# Madera South High School: Football Scoreboard Replacement: Bid No. 102124

## Pre-Bid RFI Log

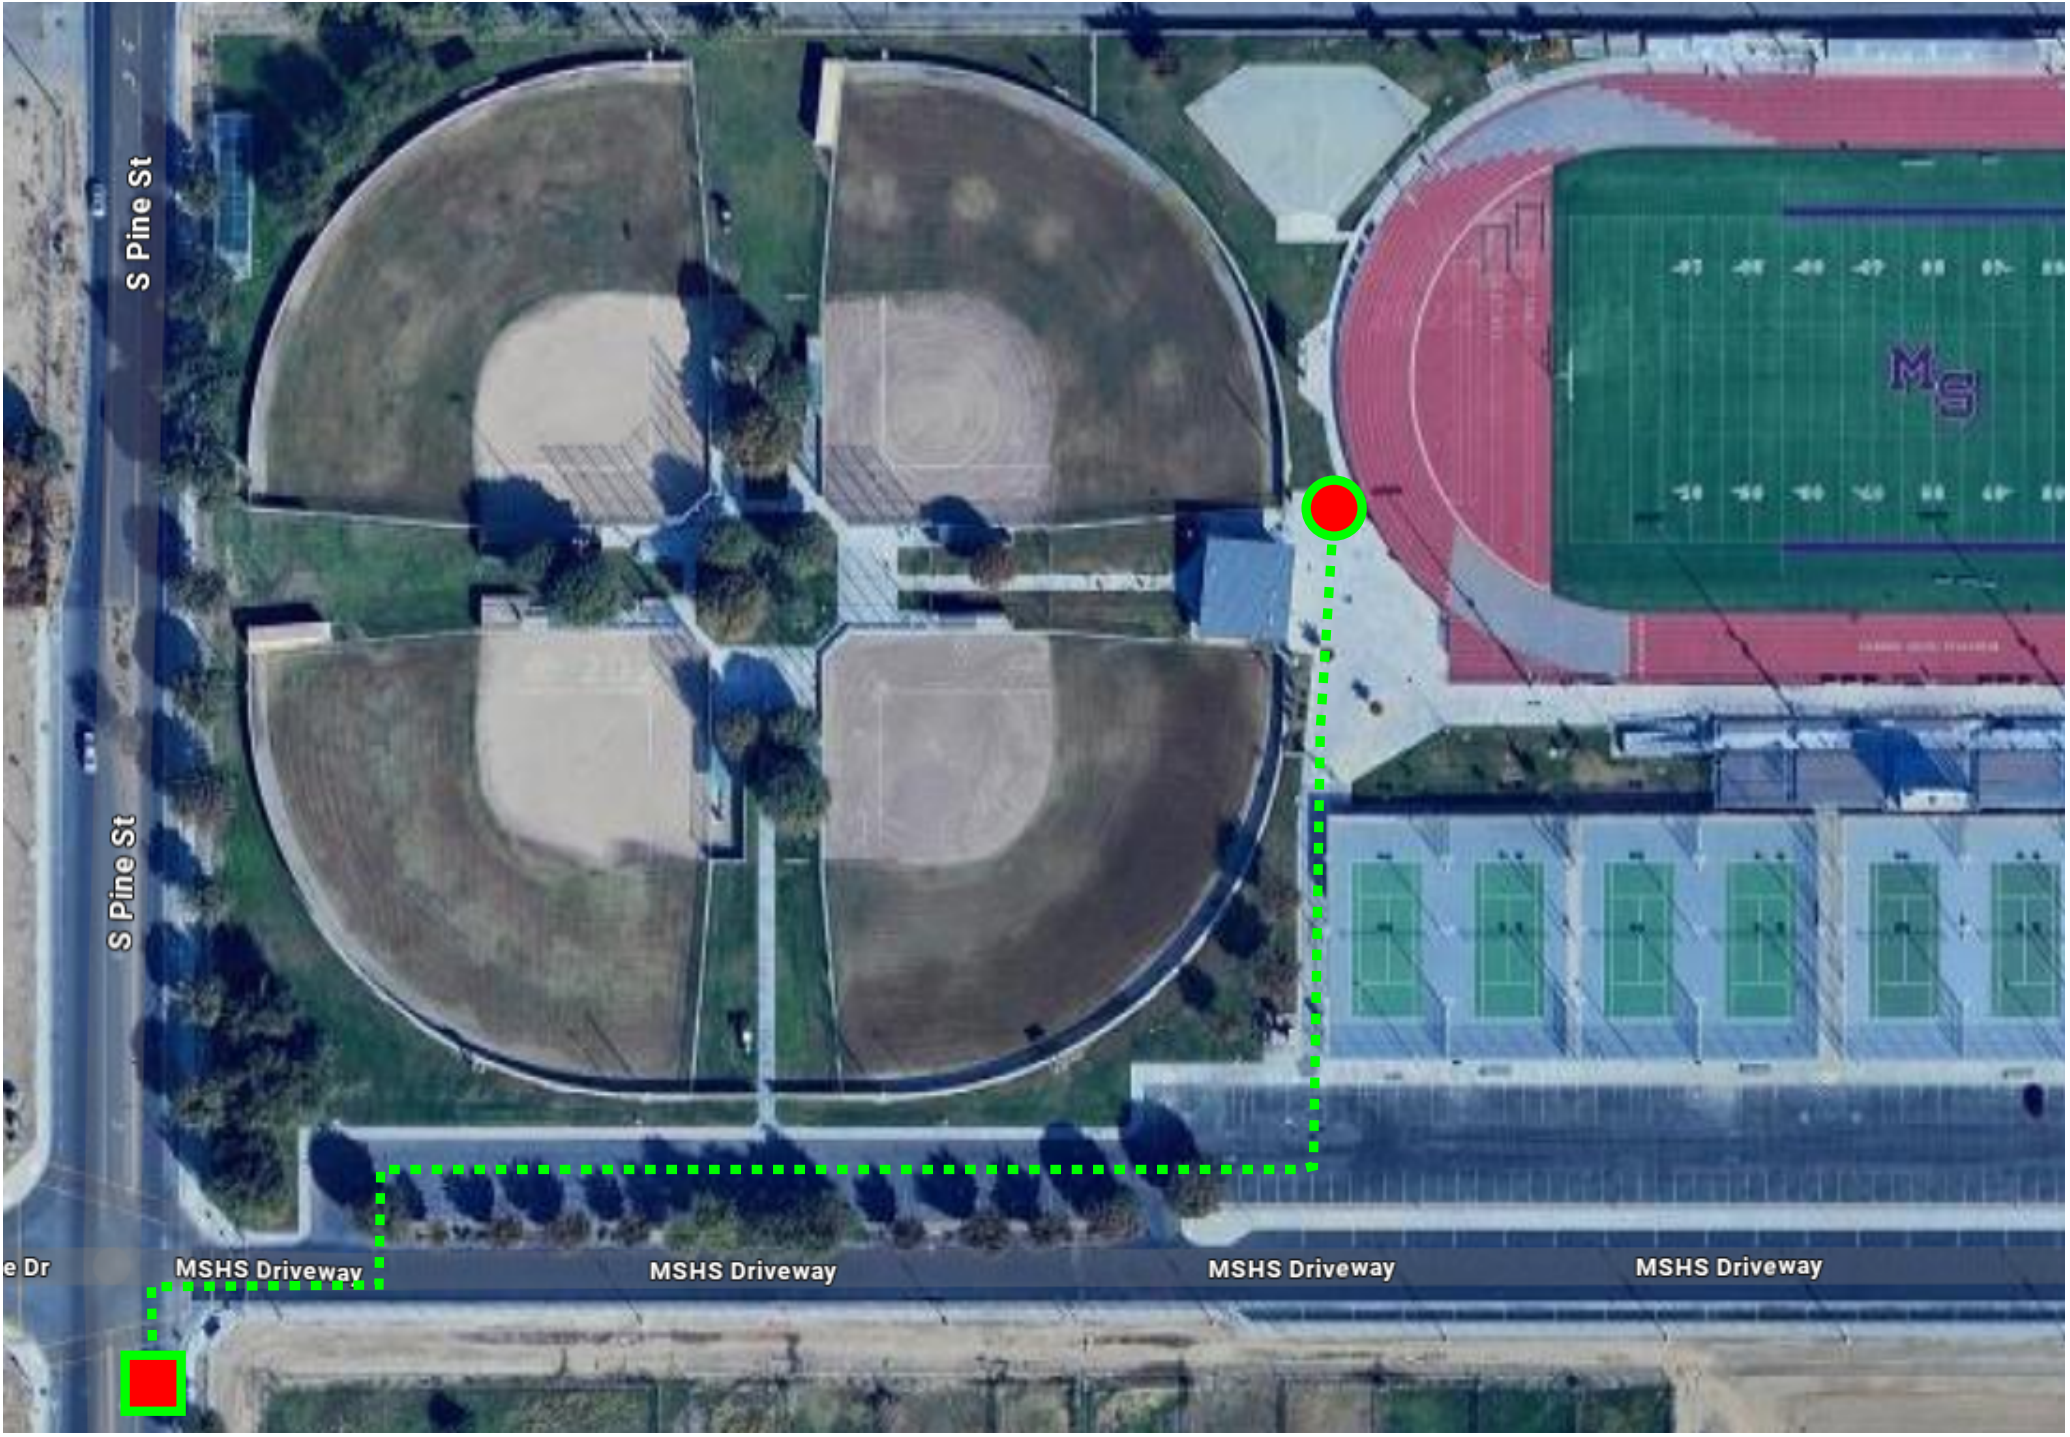
9	Will demo or installation of site concrete be required, if so, please provide details, grades, and extents.	Yes, concrete demolition will be required to remove the existing scoreboard and to establish pathway to nearest in-ground power and signal boxes. Any concrete demolition should be taken to nearest expansion joint.
10	Please provide accessible route for heavy equipment and site access.	See attached image.
11	Is the scoreboard being installed by the manufacturer?	Yes, the scoreboard is owner furnished and owner installed.
12	Is the truss option being utilized for this project?	No truss
13	Will the lateral board attachment on sheet SB5.2, detail K be installed by contractor or scoreboard manufacturer?	Contractor is responsible for supplying and installing the lateral board attachment shown in detail K on sheet SB5.2 as part of this contract.
14	Will the solar panel, speaker and video board attachment on page SB5.1. detail G, K, F, and J be utilized in this project? If so, provided and installed by whom?	No solar panel(s); no speakers; yes to the video board. Contractor shall supply brackets for video board(s) that are detailed in diagrams J and K on sheet SB5.1. Video board installation shall be accomplished by owner/scoreboard manufacturer.
